ROUNABOUT TYPICAL

PROJECT ID

118356

MED-3-20.63

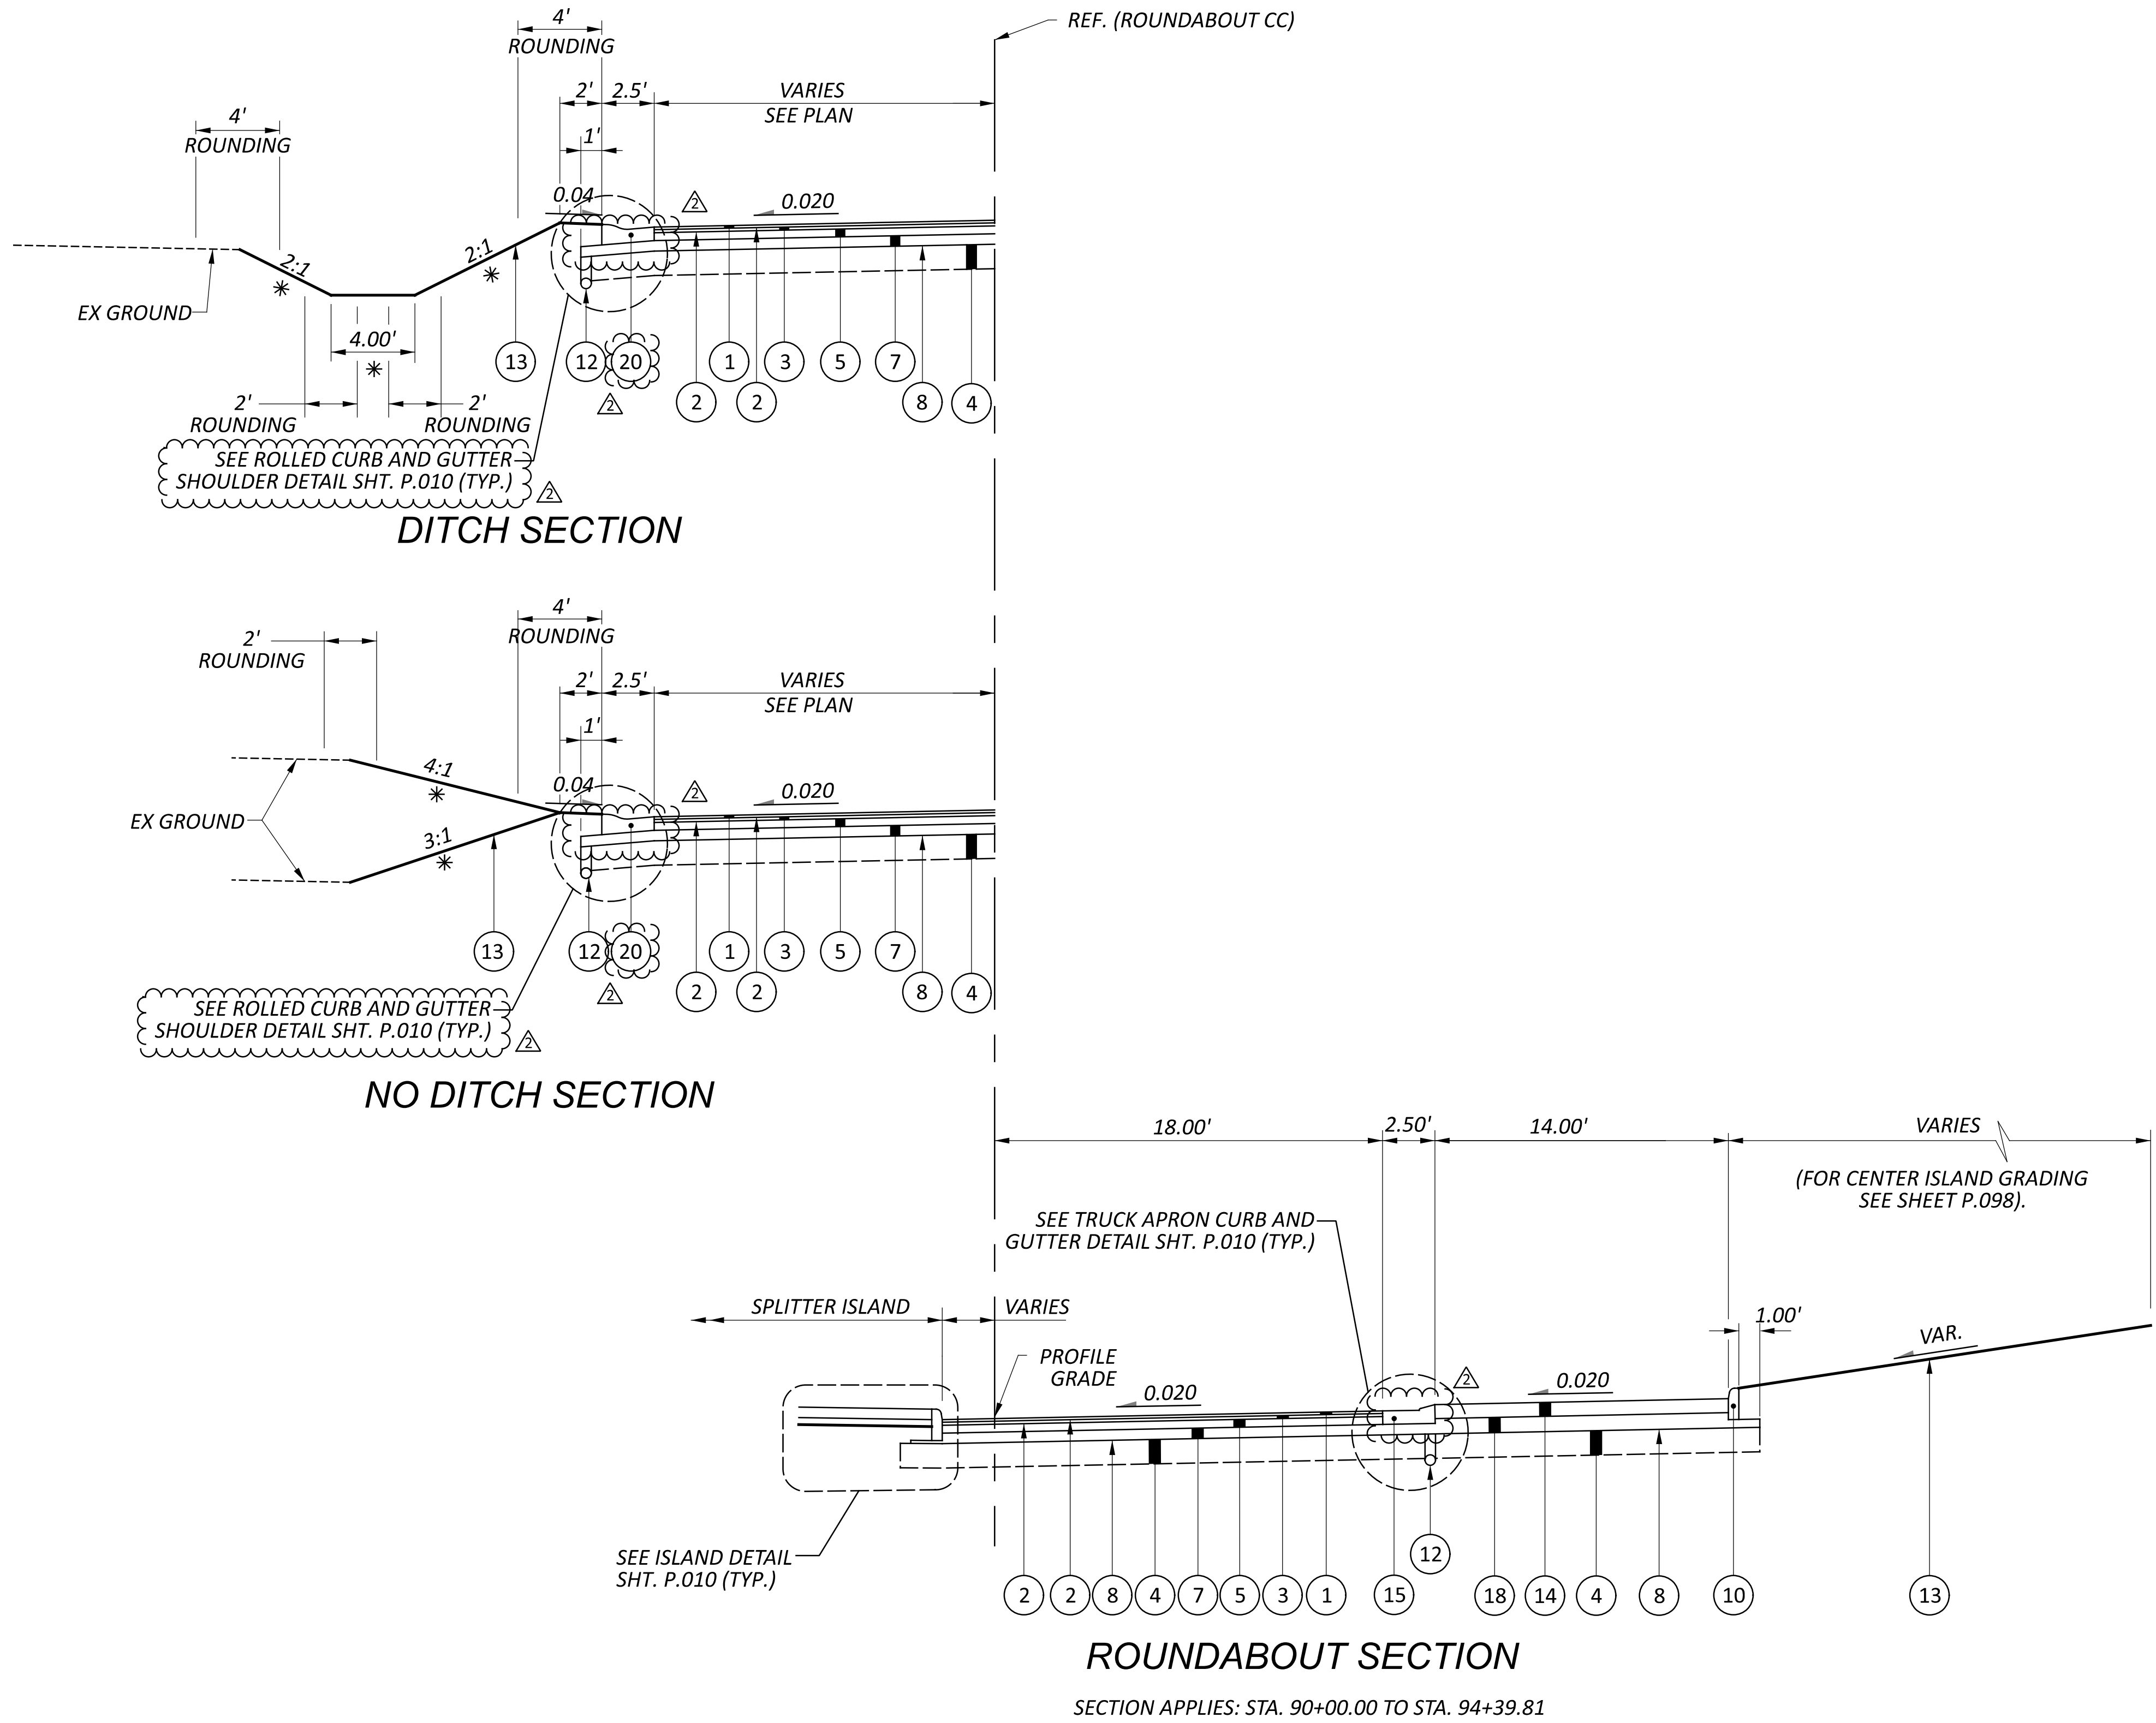
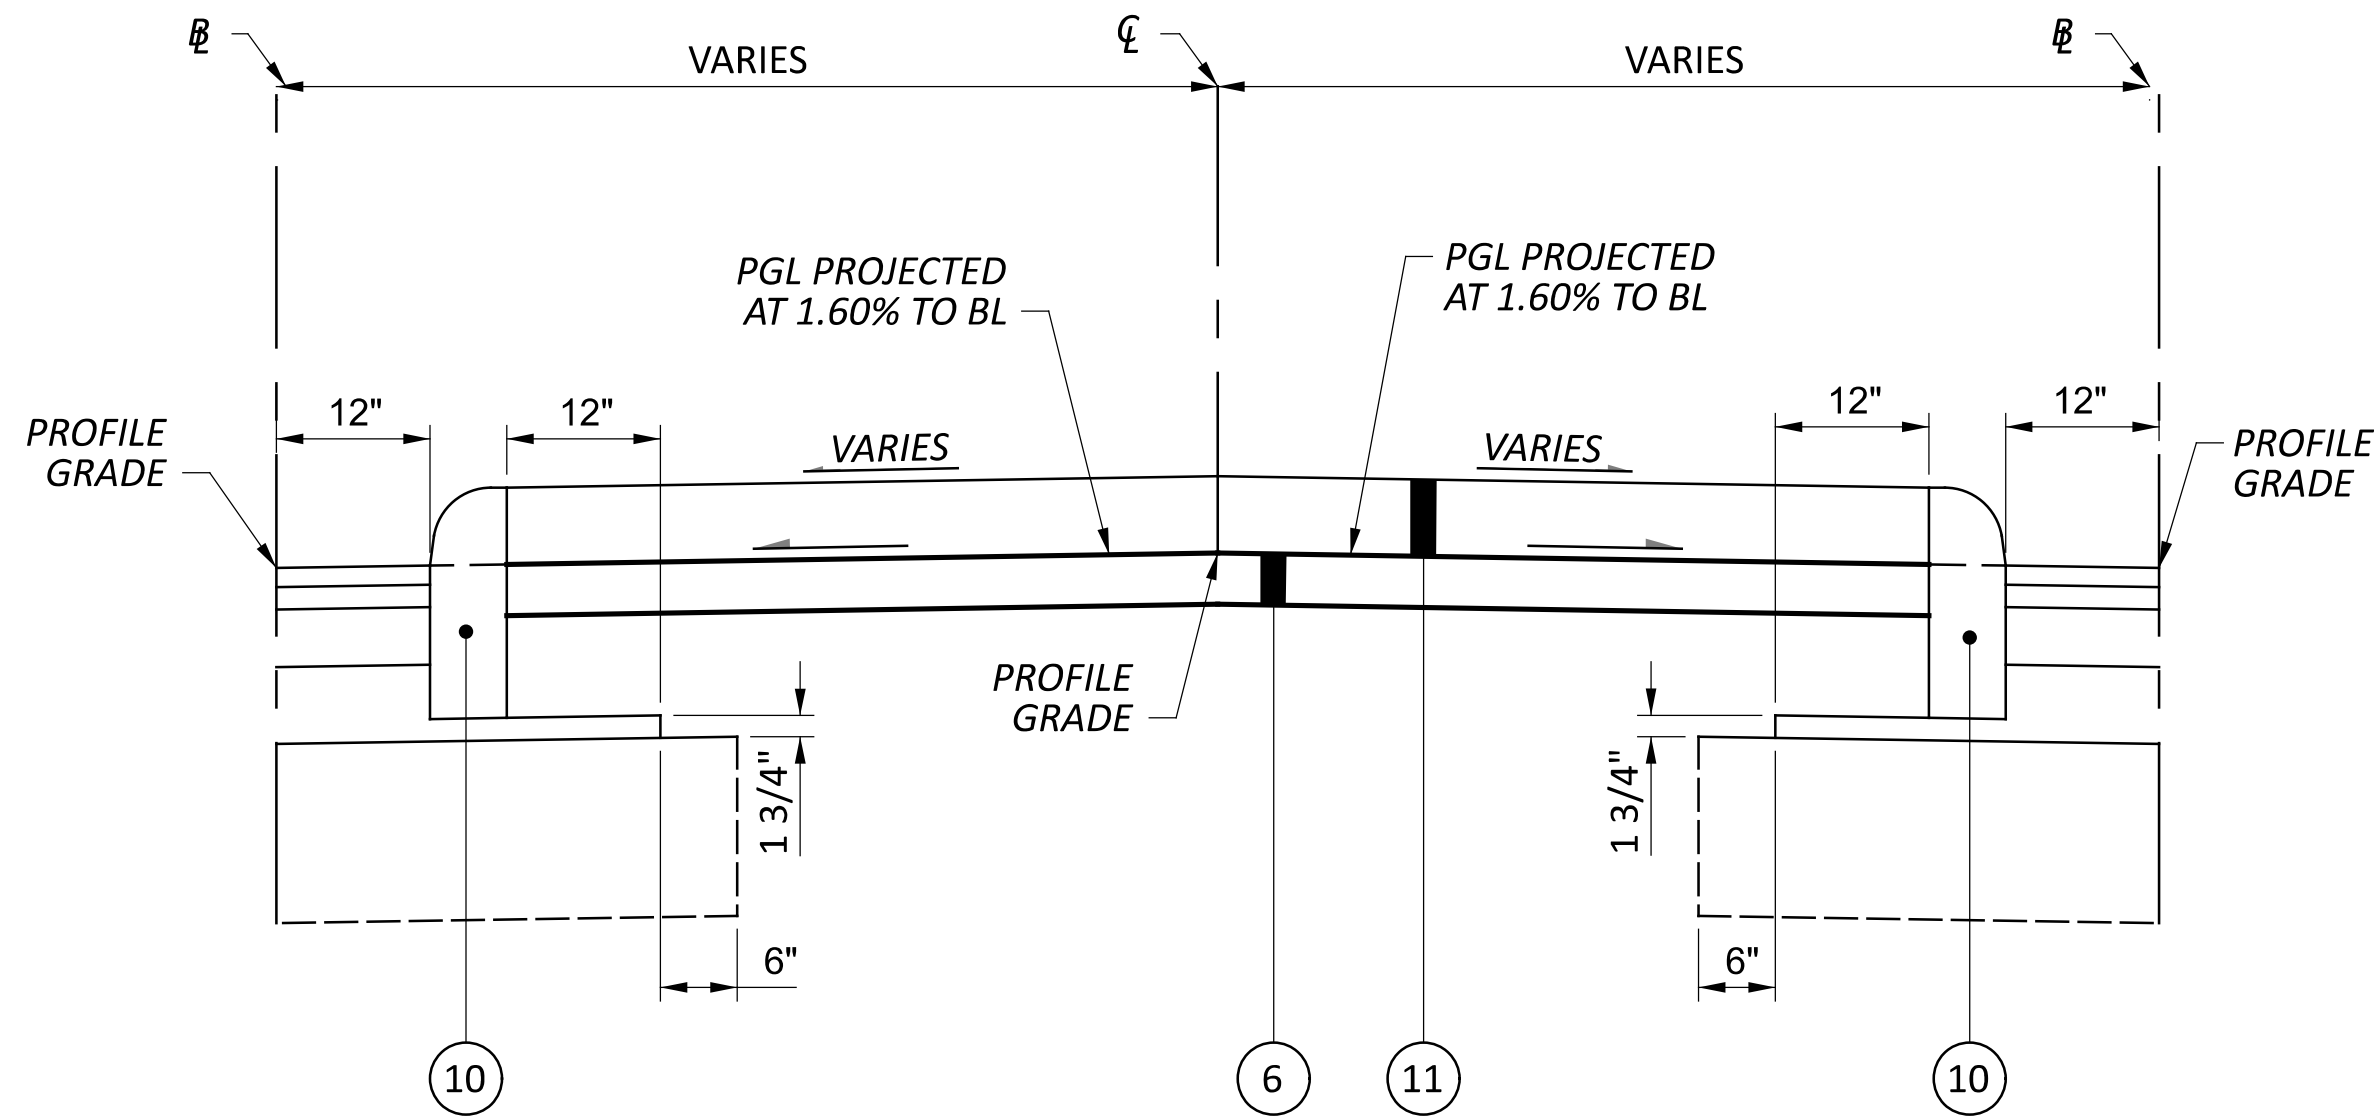
08/20/26 - ALTERED ITEM DESCRIPTIONS AND ADDED ADDITIONAL ITEM CHANGED CURBS AND ALTERED CALLOUTS
